BCA & ACCESS COMPLIANCE REVIEW

Proposed Hillsong Greater West Development

Hillsong Church – Greater West

DATE_31ST OCTOBER 2017

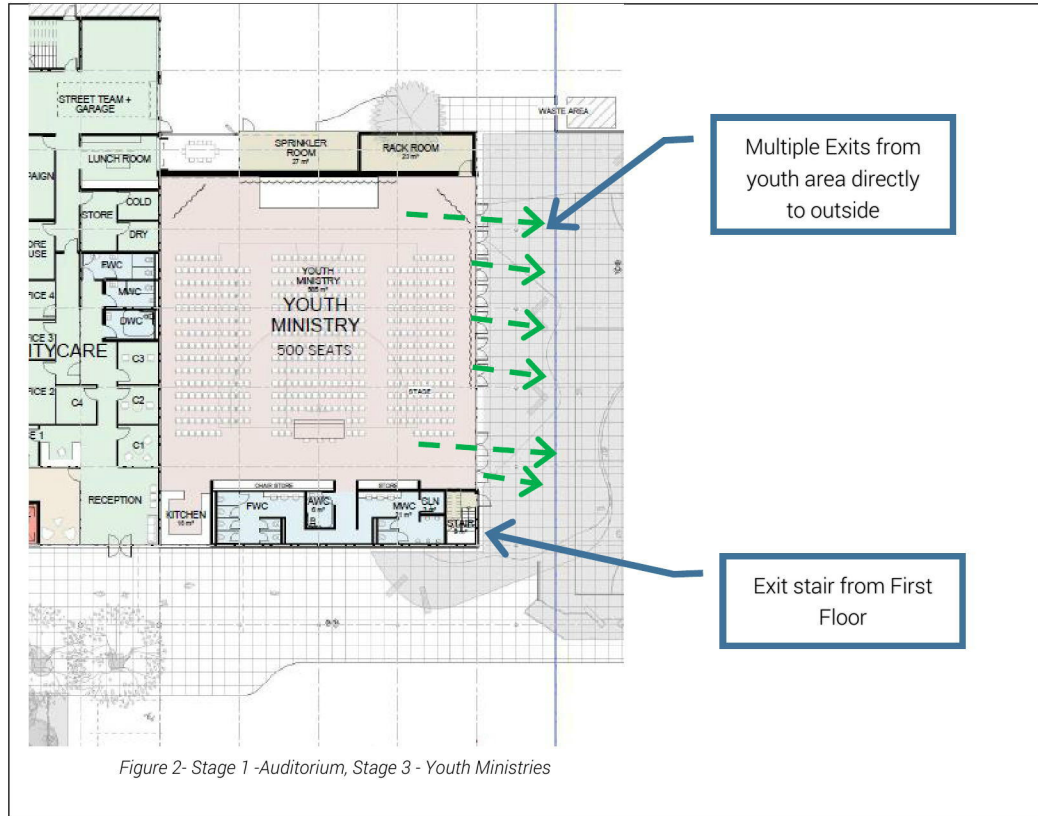
- The building is sprinkler protected, to enable the main foyer entry area and stairs to be open and not fire isolated.
- The exit stair adjacent to Treasure Chest Foyer and the stair adjacent to the loading dock are fire isolated.
- The western wall of the building is constructed as a fire wall to protect the path of travel from the fire isolated exit to the carpark open area and the street frontage.

The western southern walls of the child care centre are constructed as fire walls to protect the path of travel from the child care outside play areas to the carpark open area and the street frontage.

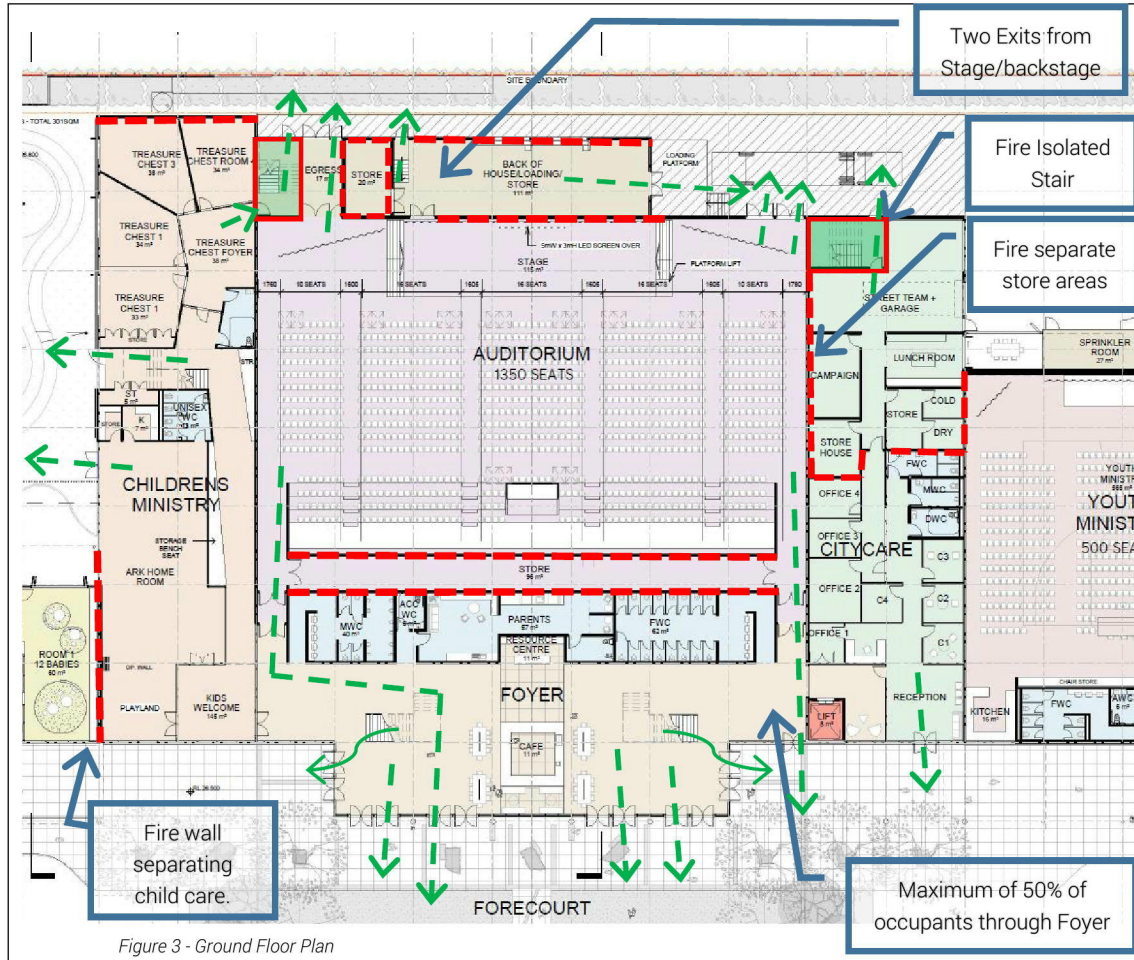
The Main Auditorium will seat approximately 1350 occupants and is classified as being an Entertainment Venue.

The exit requirements applicable to the space are:

- Minimum of 13.5m of clear exit width.
- At least two exits.
- Each exit width to be more than 1m and up to 3m wide.
- A maximum of 50% of exit width is to be via the main foyer area. This would equate to at least 6.75m of exit width is to be not through the main entry foyer.

Within the design, three exits are provided with a total exit width of 7m is provided to the western side of the building leading directly to outside.

On the ground floor level there are two exits via the main entry foyer and two more exits on the first floor that lead via the open stairs in the main foyer to ground floor and to outside.

There are a total of 13 pairs of exit doors provided from the main foyer that are expected to have a clear width of least 1500mm, giving a total exit width form the Foyer of 19.5m which will be sufficient for the occupants of the auditorium and the foyer area.

The total of the four exit paths via the foyer would be more than 6.5m and therefore the exit widths will meet the deemed to satisfy provision of the BCA for the number of occupants.

Due to the multiple exits and their locations the travel distance to an exit is less than 40m and therefore meets the DTS provisions for travel distance to an exit.

The stage and backstage area will accommodate approximately 70 occupants and is provided with two exits leading directly to outside which is sufficient for the number of occupants.

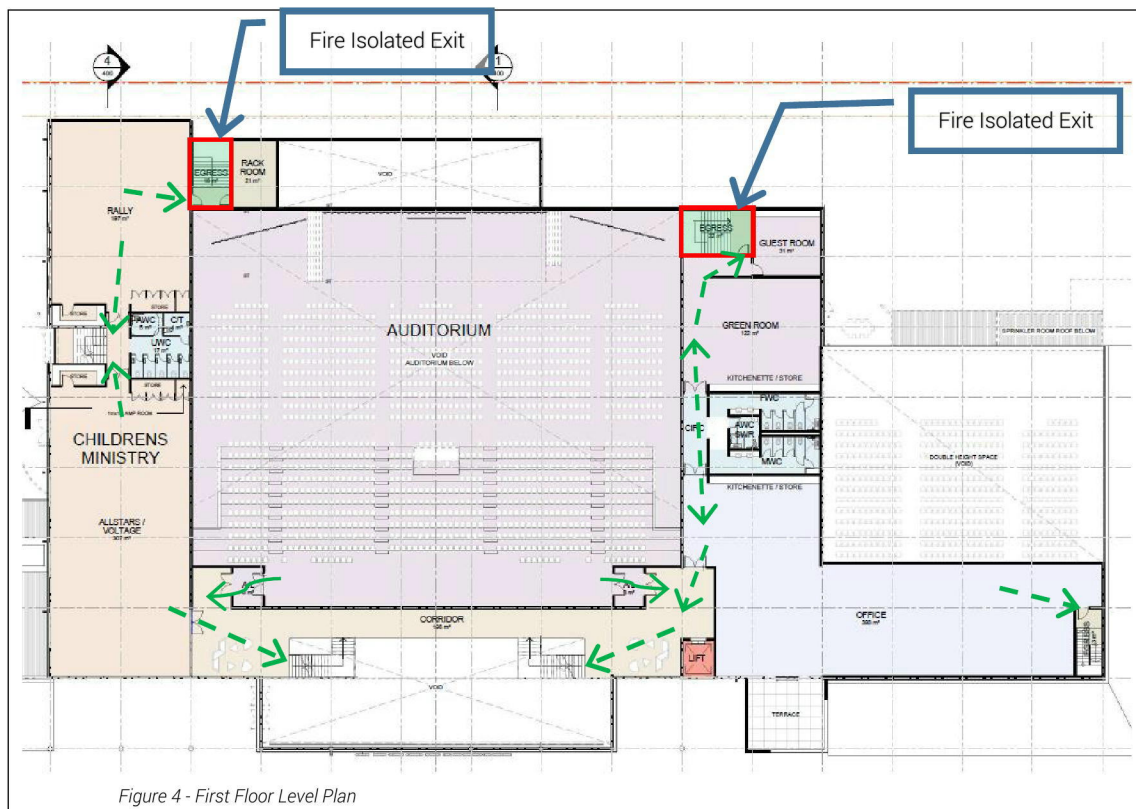
The City Care area has an entry and exit to the east side as well as a second exit via the garage to the western side of the building. The area will accommodate less than 100 occupants and therefore will only require a 1m wide exit. The exits provided will meet the deemed to satisfy provision of the BCA for the number of occupants.

The Childrens ministries area of the ground floor will accommodate up to 85 occupants. The area has an entry from the main foyer, via the lift the Kids Welcome Foyer. There is an additional exit directly to the outside play area on the south side of the building. These two exits will provide sufficient exit width for the number of occupants and exit travel distances to meet the Deemed to Satisfy provisions of the BCA. Refer to the figure above.

The Treasure Chest Childrens Ministry are will accommodate up to 70 occupants. The area has access from the Kids welcome foyer via the central corridor. The area is provided with an exit via the western fire isolated stair as well and an exit via the central corridor to the Outdoor play area, giving the area at least 2 exits. These exits will provide sufficient exit width for the number of occupants and exit travel distances to meet the Deemed to Satisfy provisions of the BCA. Refer to the figure above.

Figure 5- Second Floor Plan

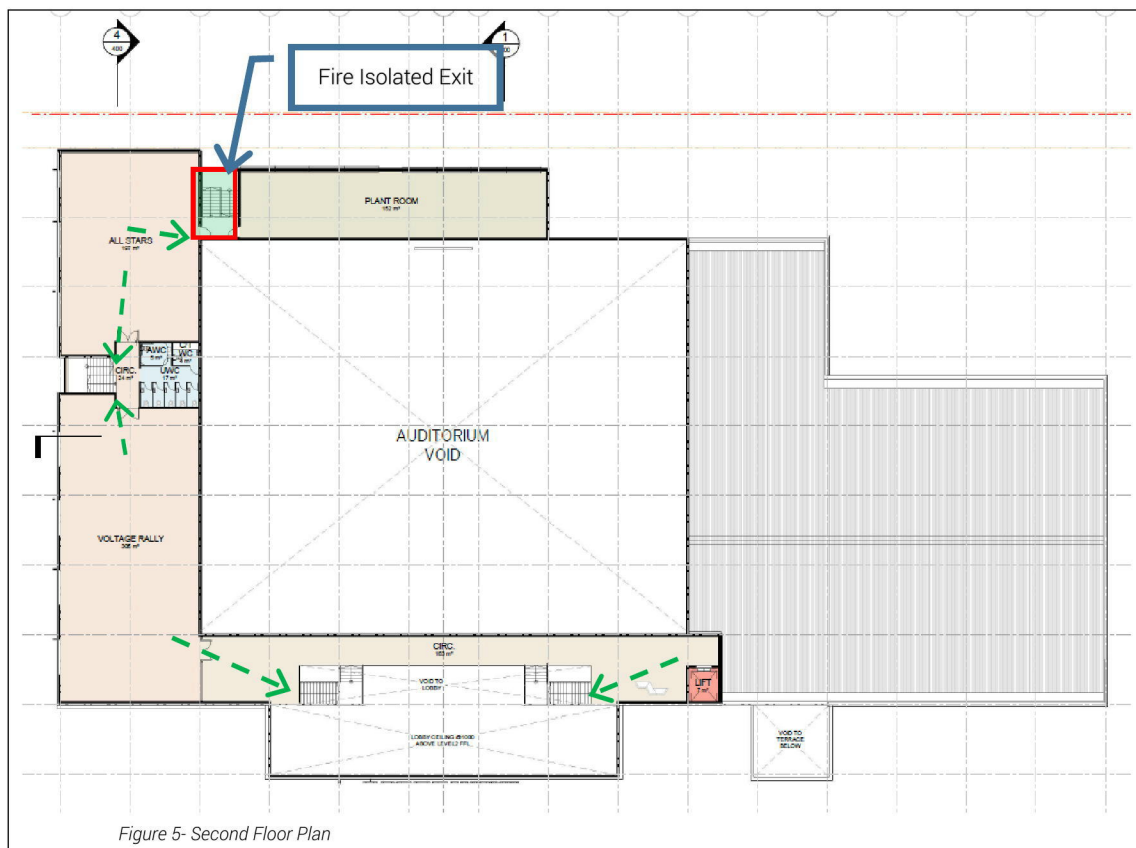
The second floor area is divided into two separate functions of the Voltage group and the All Stars group.

The Voltage Rally area on the second floor will accommodate up to 154 occupants.

The area has an entry from the main foyer, via the lift and the main foyer open stair. The stair is also used as an exit form this level.

The area is provided with a second exit via the open stair to the southern end of the building leading into the adjacent play area.

These two exits have a total width of at least 3.5m and therefore will provide sufficient exit width for the number of occupants and exit travel distances to meet the Deemed to Satisfy provisions of the BCA. Refer to the figure below.

The All Stars area on the second floor will accommodate up to 99 occupants.

The area is provided with an exit via the western fire isolated stair as well and an exit via the open stair to the southern end of the building leading into the adjacent play area.

These two exits will provide sufficient exit width for the number of occupants and exit travel distances to meet the Deemed to Satisfy provisions of the BCA. Refer to the figure below.

2.5.6.6 CHILD CARE CENTRE - GROUND FLOOR LEVEL

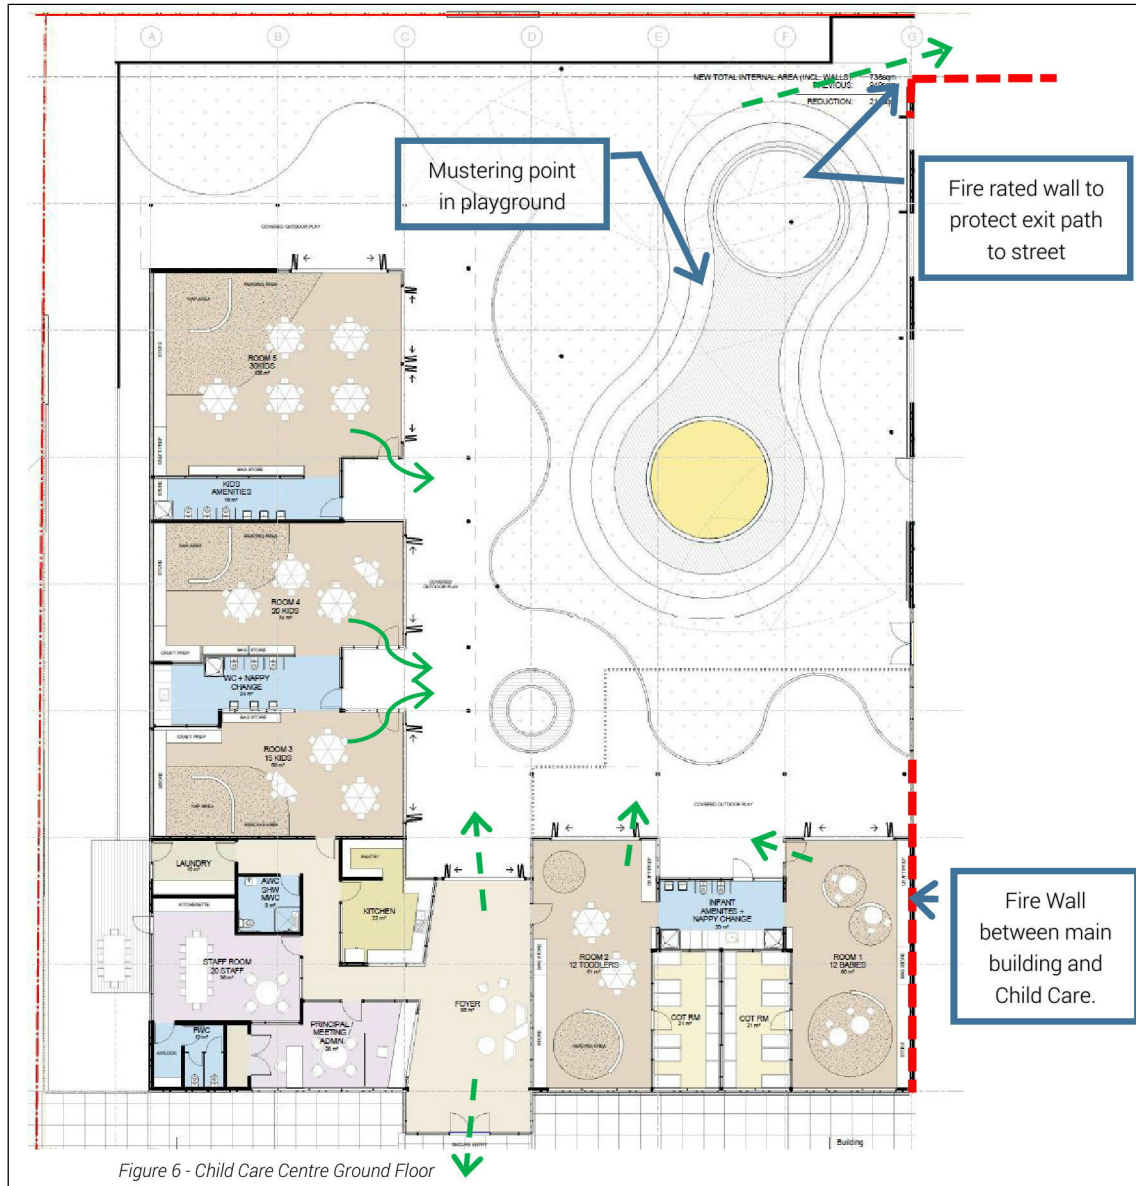
The Child care centre is located to the southern side of the main building and will accommodate up to 90 children plus up to 20 staff.

The main entry to the area is to the eastern side of the building from the main forecourt area, which also functions as an exit. Each of the play rooms have direct access to the central outdoor play area, which will be used as an evacuation muster area.

The western side of the main auditorium is to be provided with a fire wall to protect the exit path to the street via the carpark.

These two exits will provide sufficient exit width for the number of occupants and exit travel distances to meet the Deemed to Satisfy provisions of the BCA. Refer to the figure below.
